ADDENDUM No. TWO

Project Name: Nature Center
White Clay Creek State Park

Contract No.: NAT25805-NATCTR
Date of Issue: Wednesday, May 20, 2026

1 LOWER FLOOR PLAN - SYSTEMS - NEW WORK
EY1.1 SCALE: 1/8" = 1'-0"

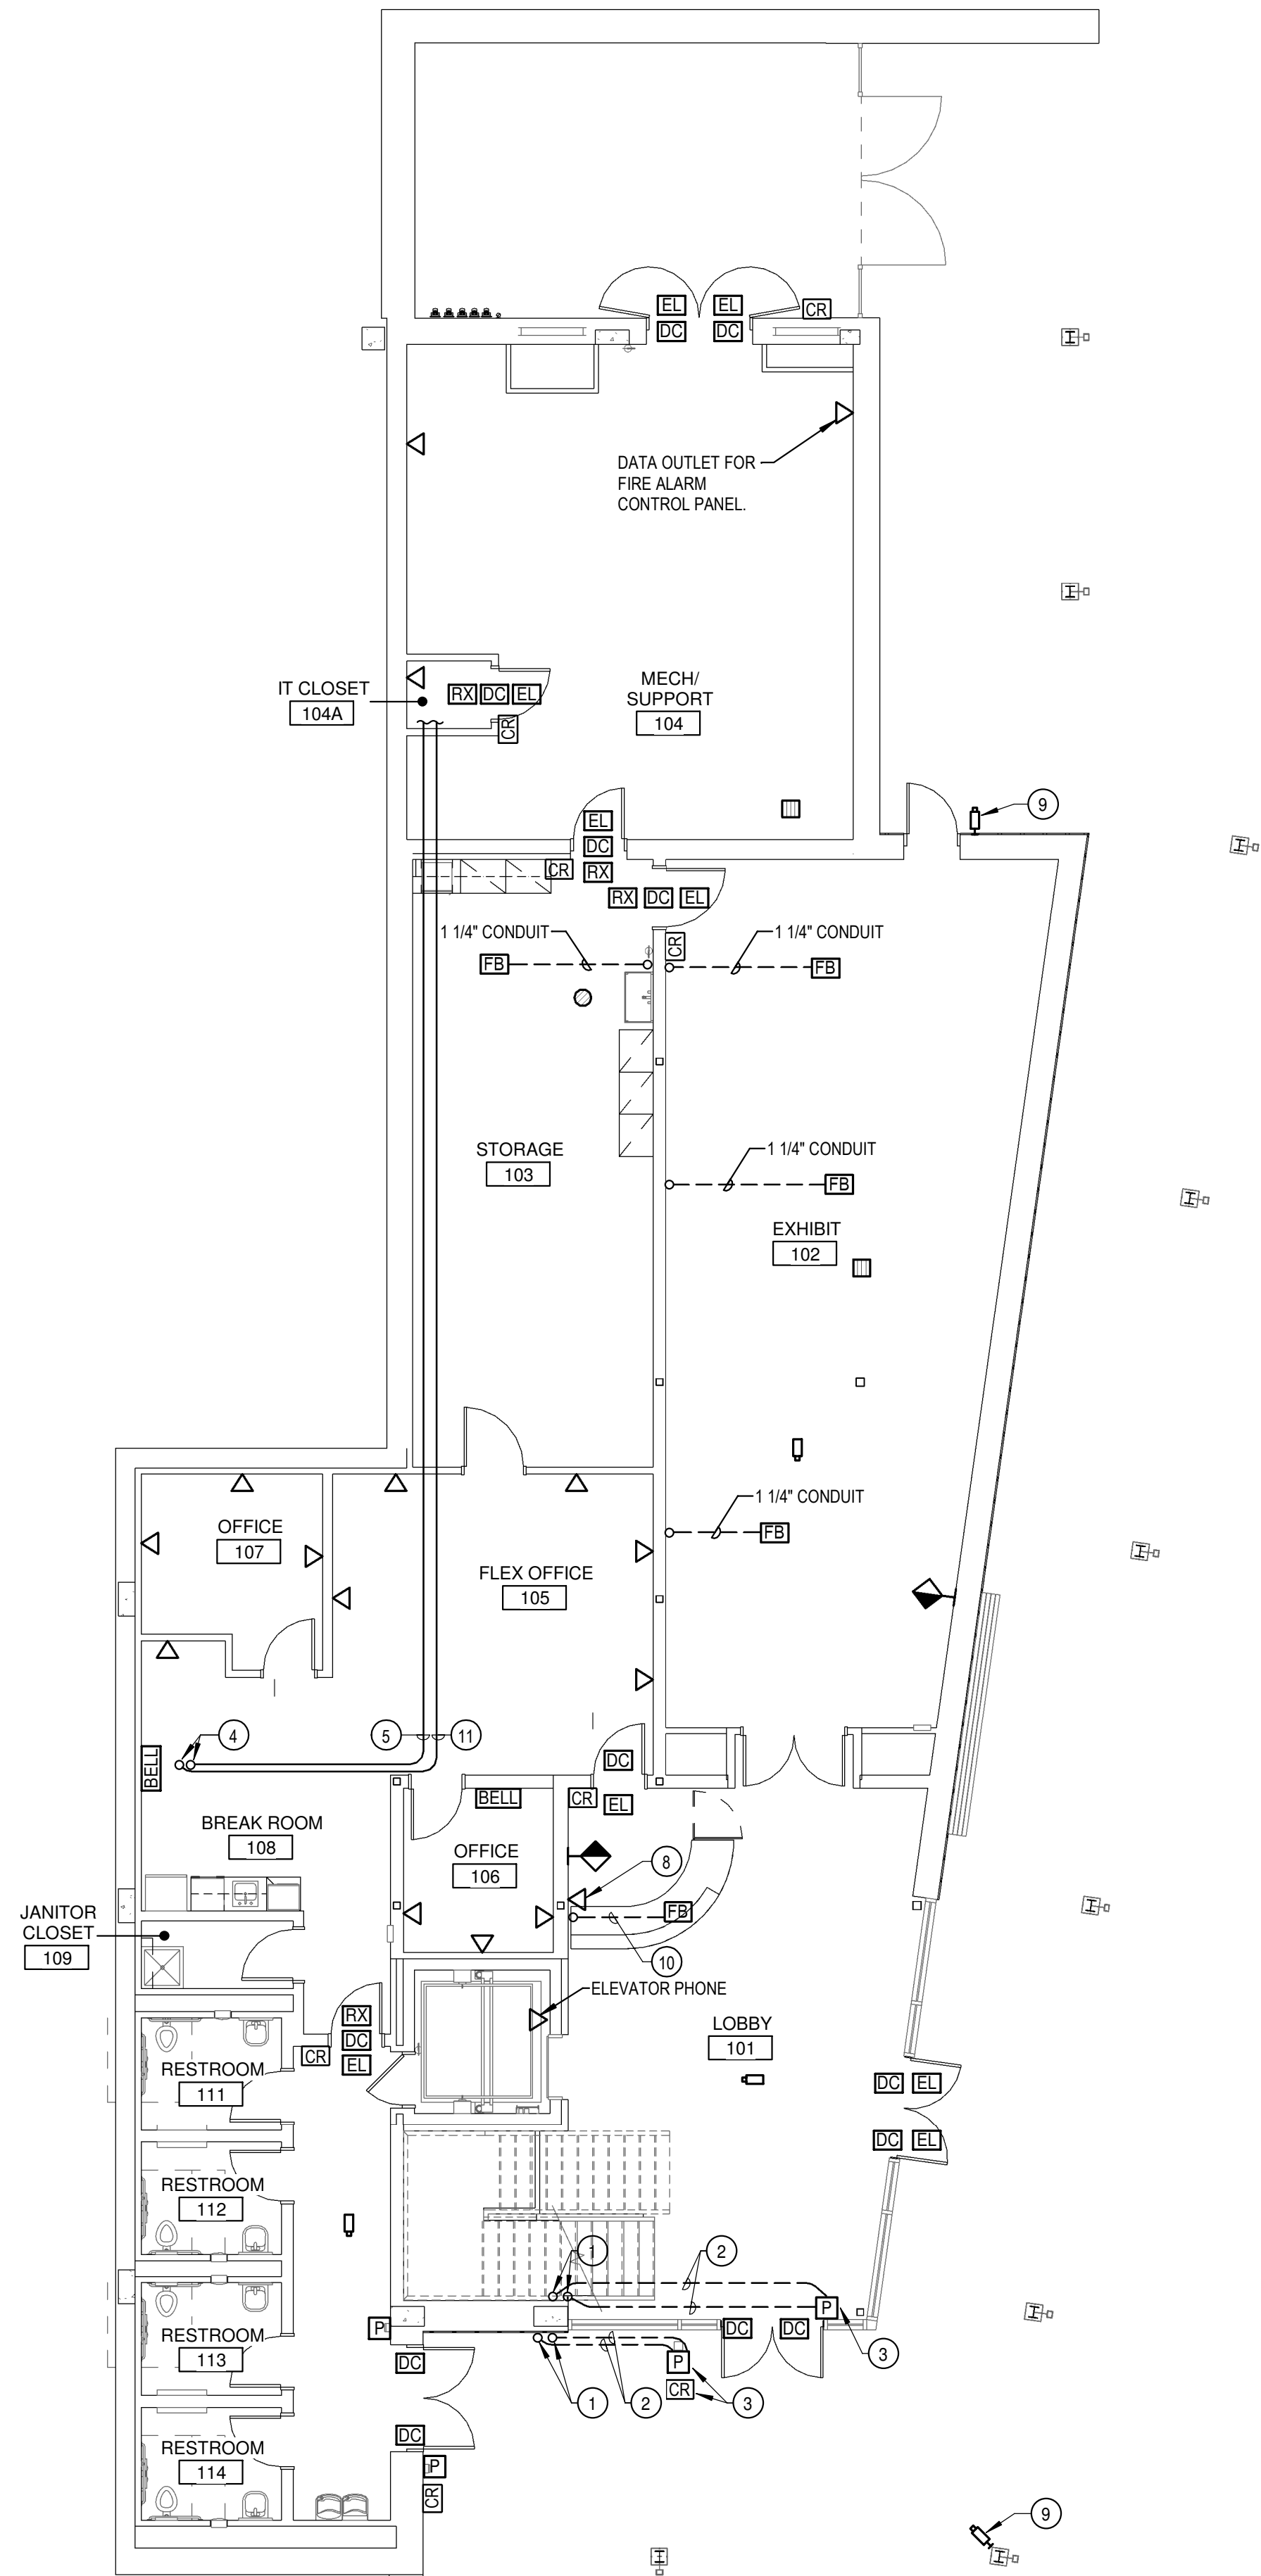
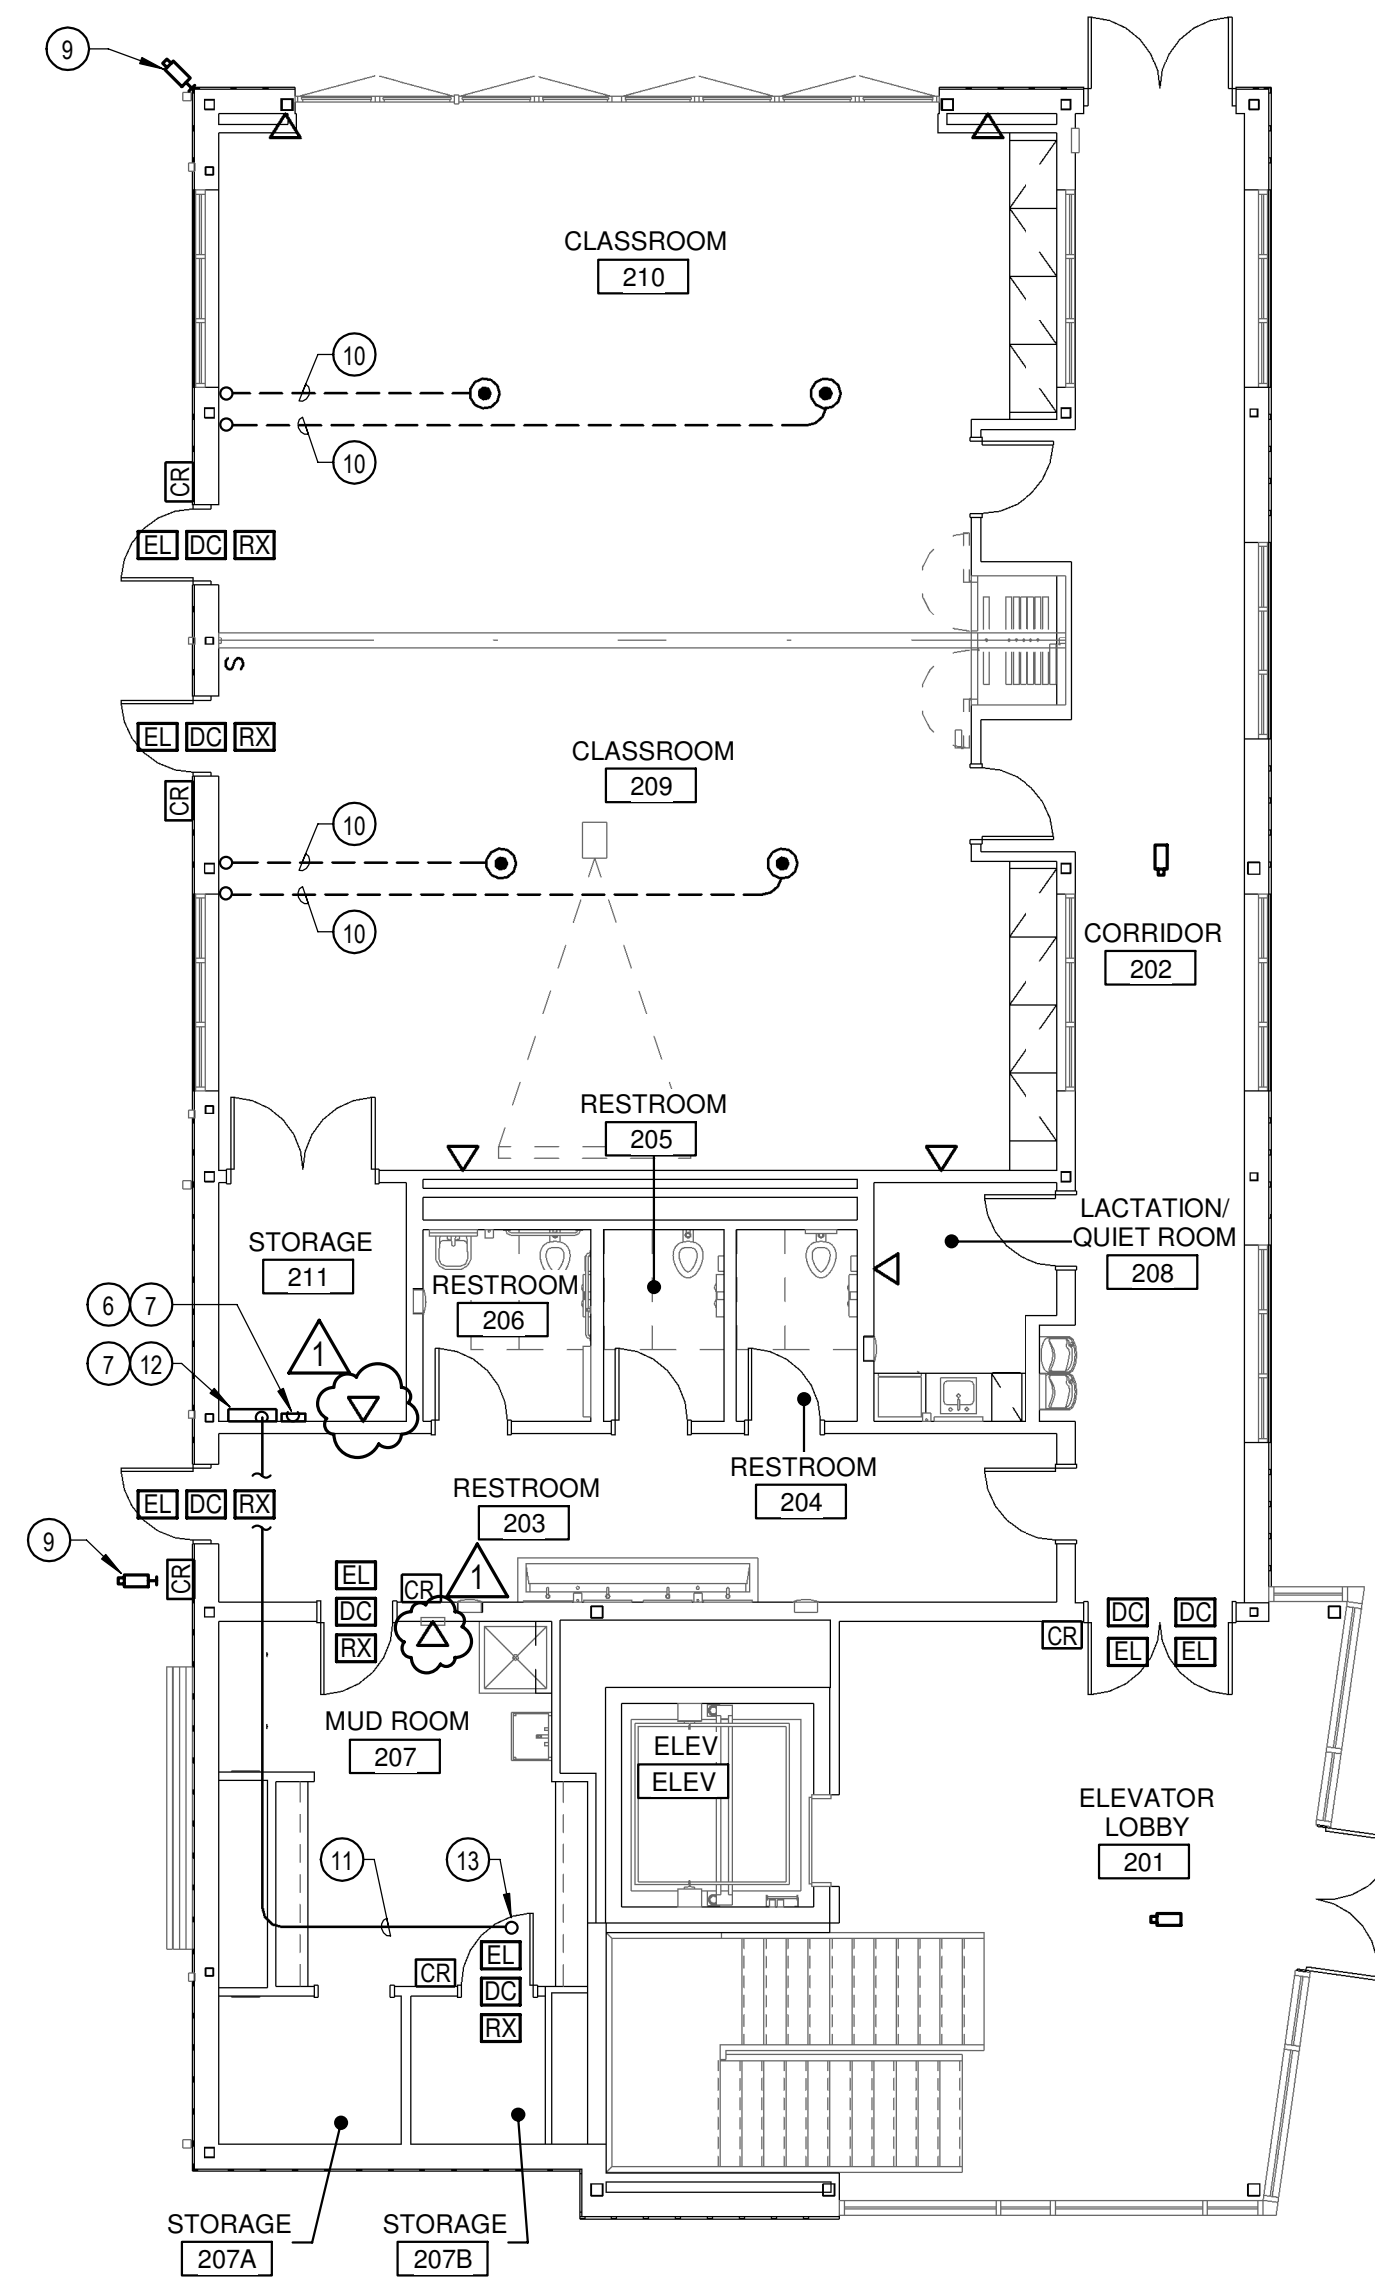
5. Sheet EY1.1: LOWER & UPPER FLOOR PLAN – SYSTEMS – NEW WORK
ADD: One (1) new box provision for a data outlet connection has been added to Storage 211 to serve new AV equipment associated with the overhead projector located in Classroom 209.
ADD: One (1) new box provision for a data outlet connection has been added to Mud Room 207 to serve either a PC or a phone.
